AGENDA
City Planning Commission
September 23, 2026, 5:30 PM
Council Chambers – Hillsdale City Hall

VI. Consideration of Applications
- a. Commercial Site Plan Review – 8 E Bacon
- b. Commercial Site Plan Review – Hillsdale College Turf Building

Re: **Commercial Site Plan Review – 8 E Bacon St, Accessory Structure**

Re: **Preliminary Site Plan Review**

PRE-DEVELOPMENT IMPACTED DRAINAGE AREAS TRIBUTARY TO THE EXISTING DETENTION BASIN

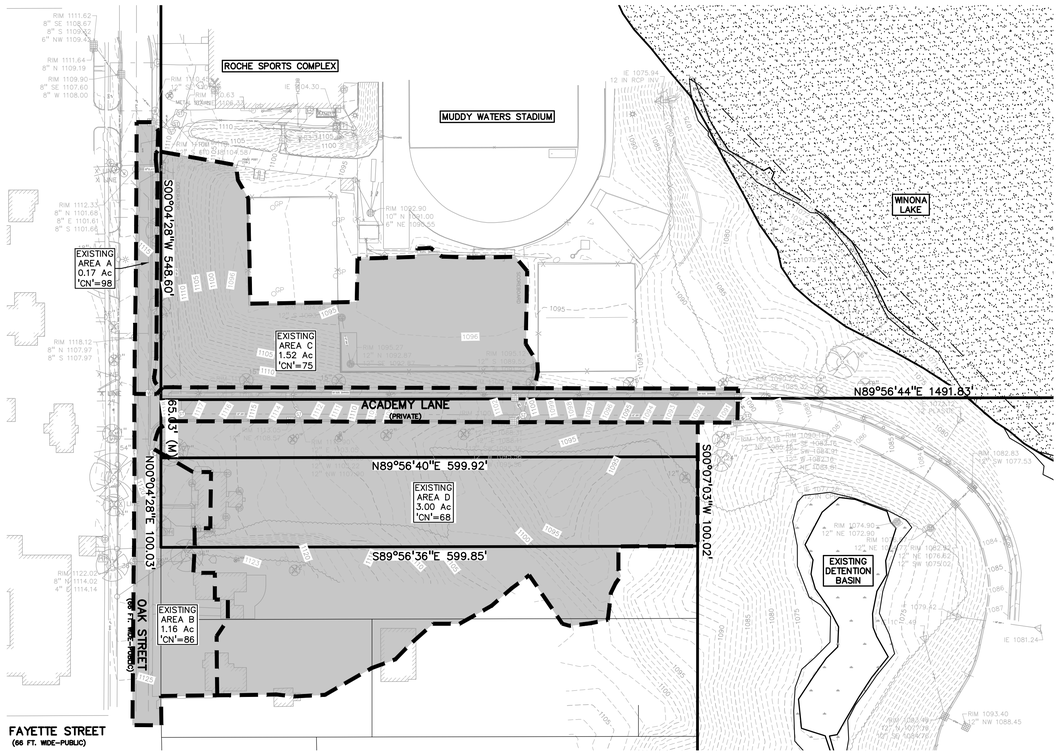
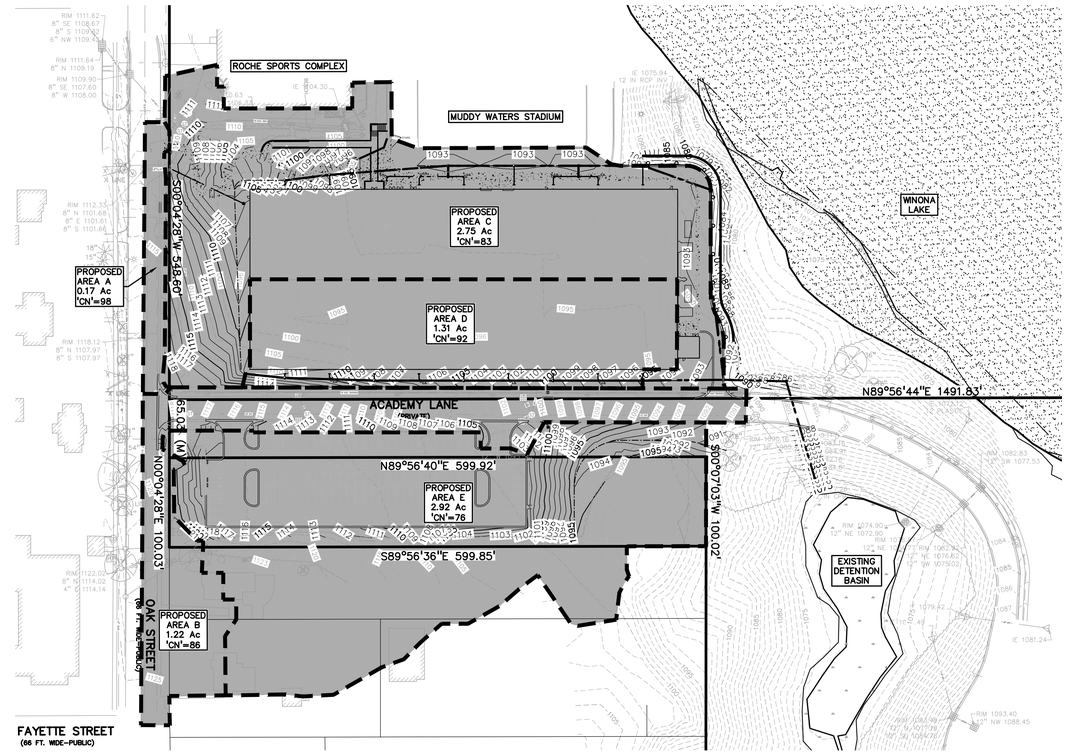
- **Response: Refer to sheet C-8.1 for detention calculations.**
    - The detention basin is sized for the change for the site, but all the storm sewer on the north and east side of the proposed Turf Building, by-passes the detention basin.

- **Response: Refer to sheet C-8.1 for outlet control calculations.**
    - No calculations were provided for the existing detention basins is impacted by the proposed work or calculations for the revisions to the outlet control into Winona Lake.

- **Response: Refer to sheet C-8.1 for detention calculations.**
    - No Pipe sizes or pipe materials are shown for the storm sewer.
        - **Response: Refer to sheet C-6.0 for pipe sizes and materials.**

- **Response: Refer to sheet C-8.1 for detention calculations.**
    - No dimensions are provided for the detention basin.
        - **Response: Previously proposed detention basin has been removed from the plans.**

DRAWING NUMBER:
C-8.2

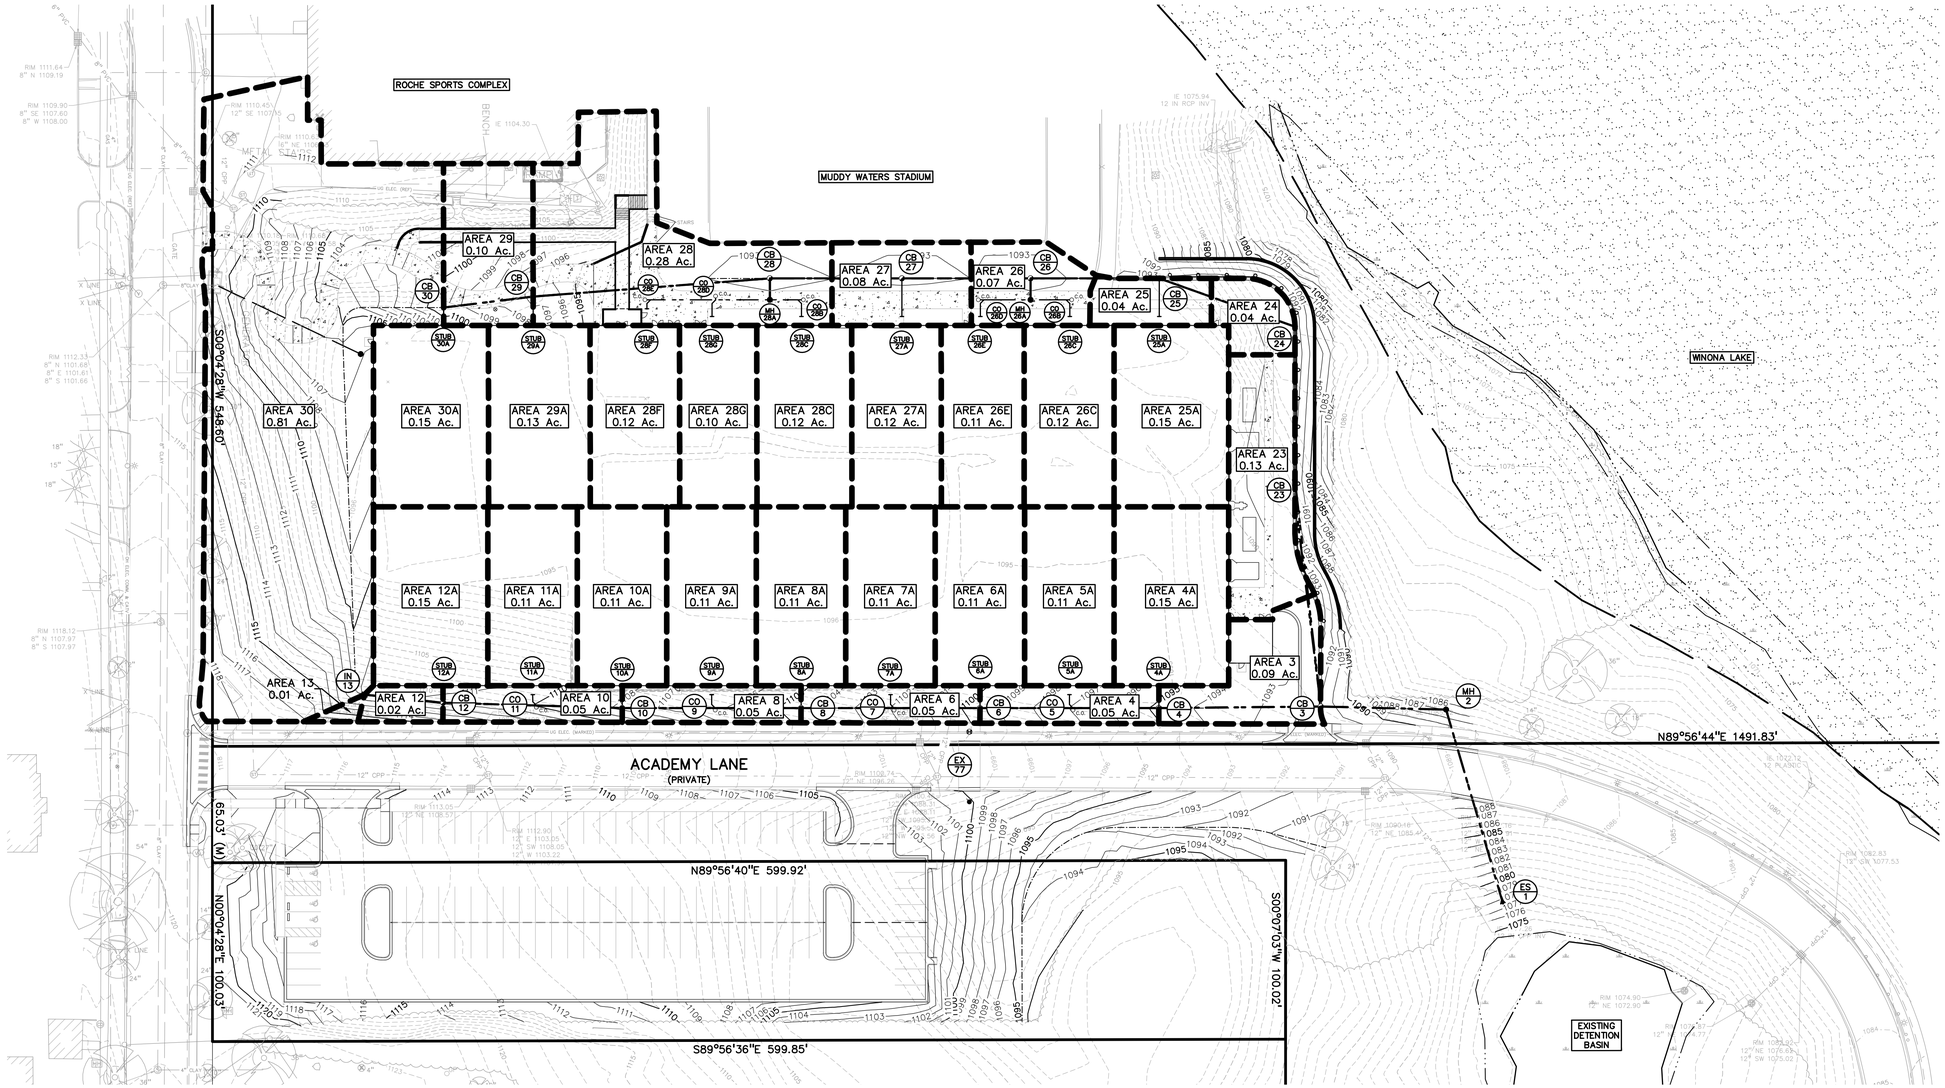
- No pipe sizing calculations were provided.
        - **Response: Refer to sheet C-8.2 for storm sewer calculations.**
    - Would recommend a plan view with the tributary areas for the basins to be provided to correspond to the pipe sizing calculations.

- **Response: Refer to sheets C-8.1 and C-8.2 for drainage areas.**
    - No outlet control structure, or metering line calculations were provided for the proposed detention basin.

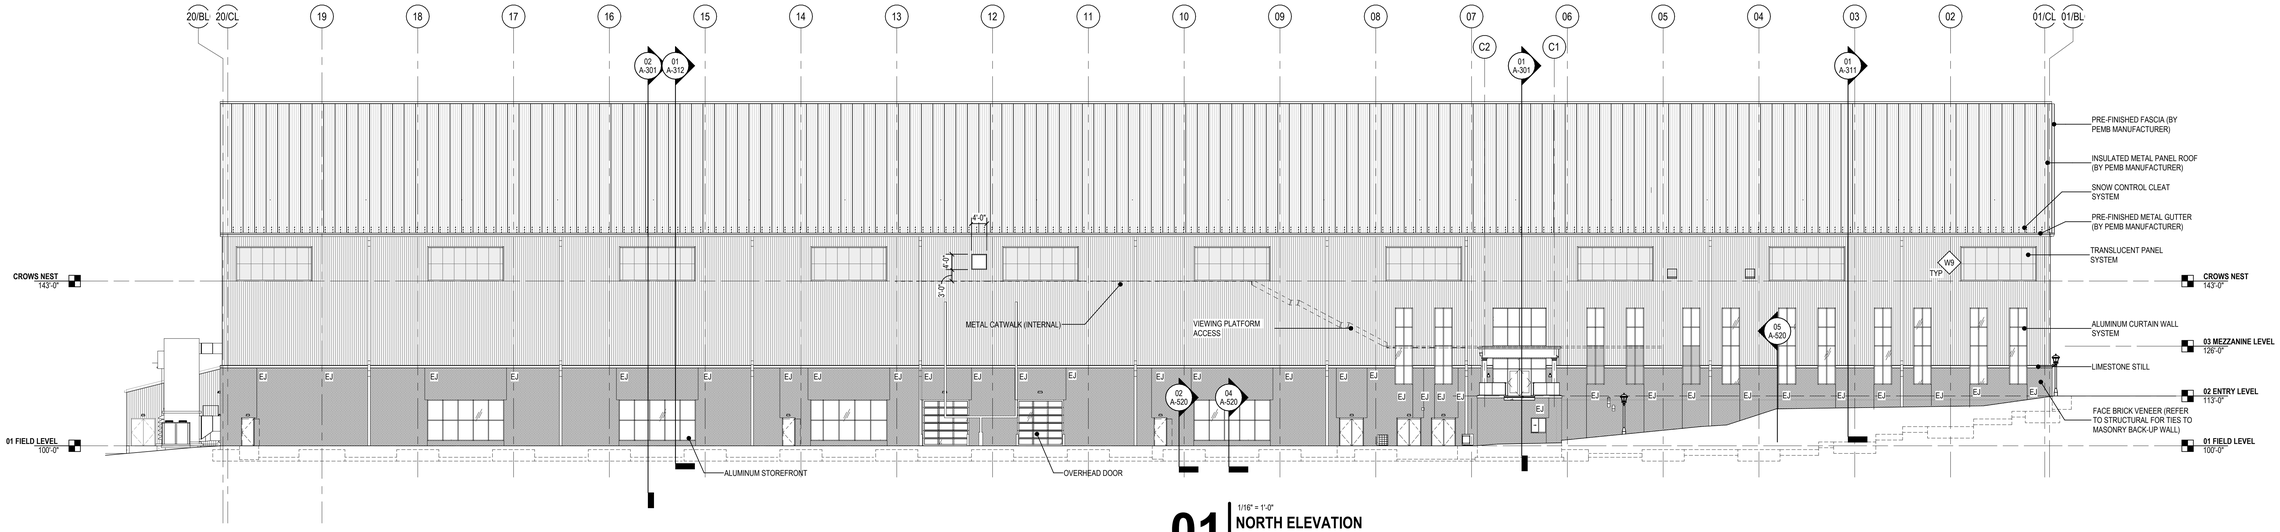
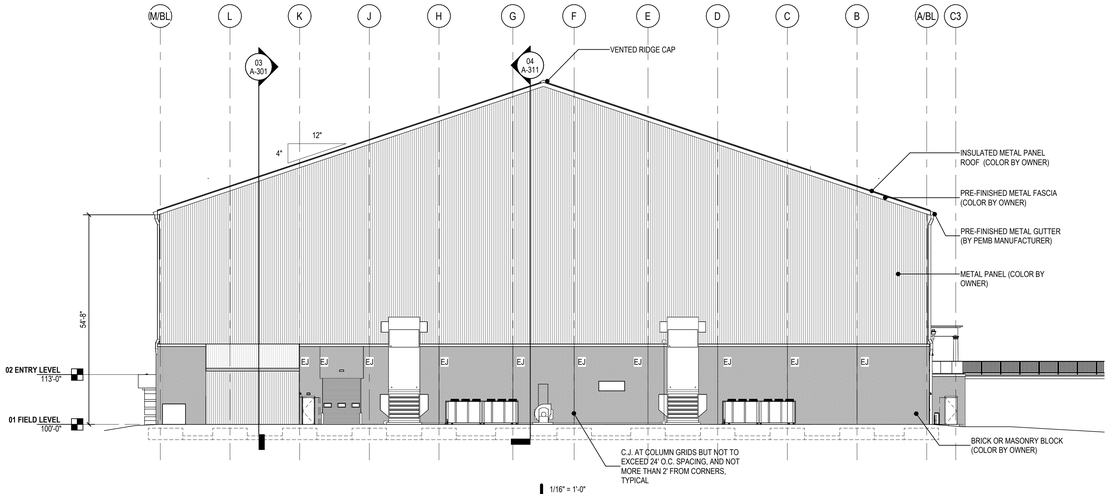
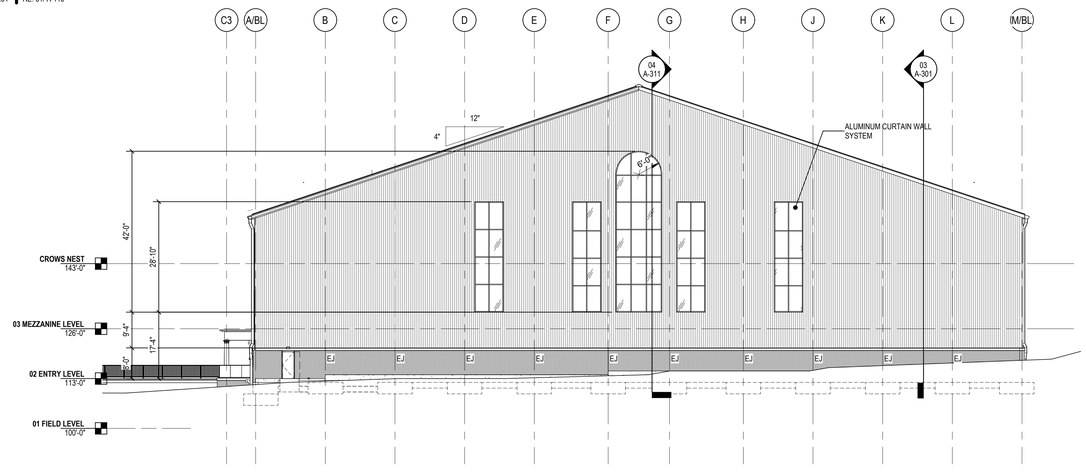
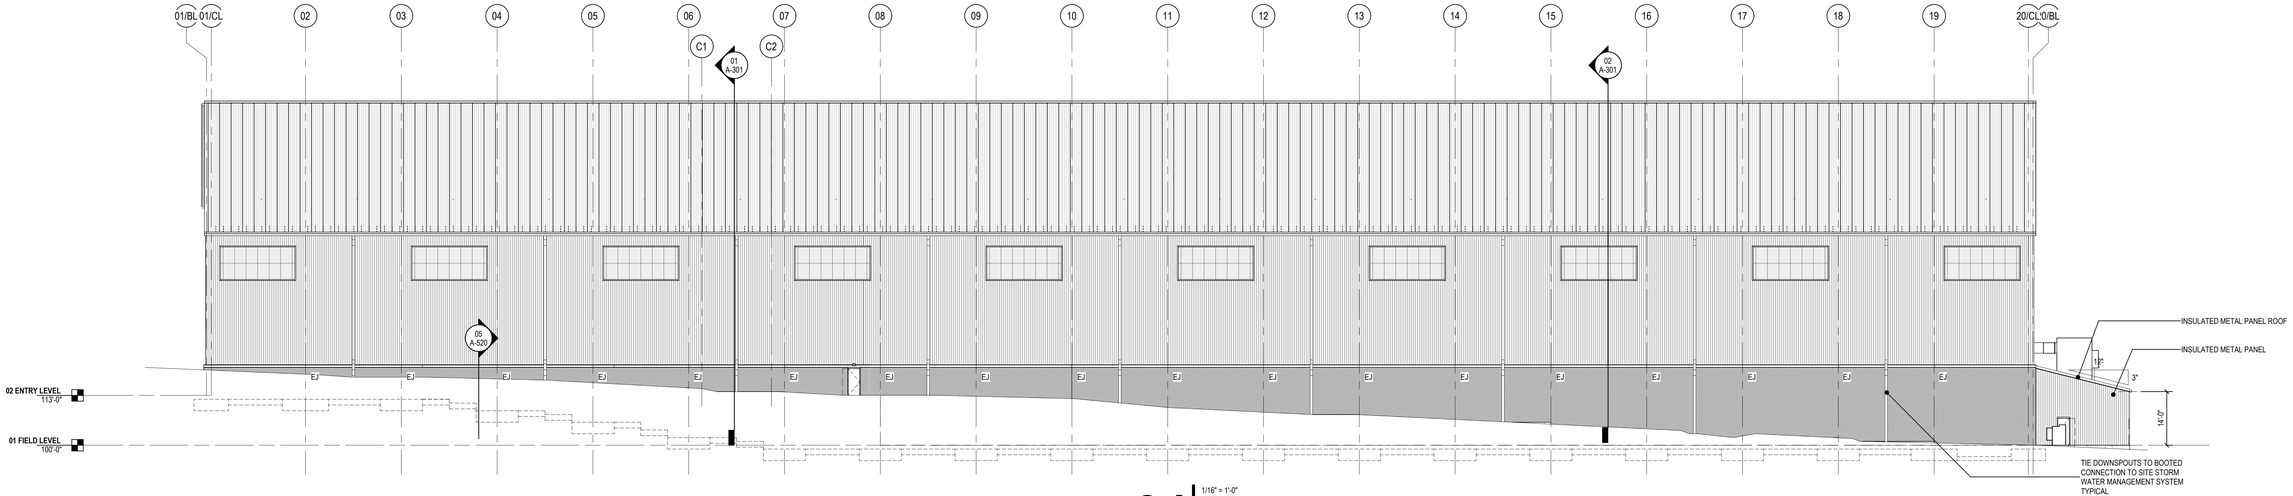
- Per Sec. 36-411, the maximum height of the structure is limited to 4 stories or 50'. The proposed building height is 55' due to one split-level story.
  - Without seeing elevations or building renderings to better understand the split-level story, a dimensional variance would need to be requested by the Zoning Board of Appeals.

- **Response: The parking lot is proposed to be setback 21.18 – 22 feet from the adjacent residential property line, as shown on sheet C-3.0.**
- Per Sec. 36-411, the maximum height of the structure is limited to 4 stories or 50'. The proposed building height is 55' due to one split-level story.
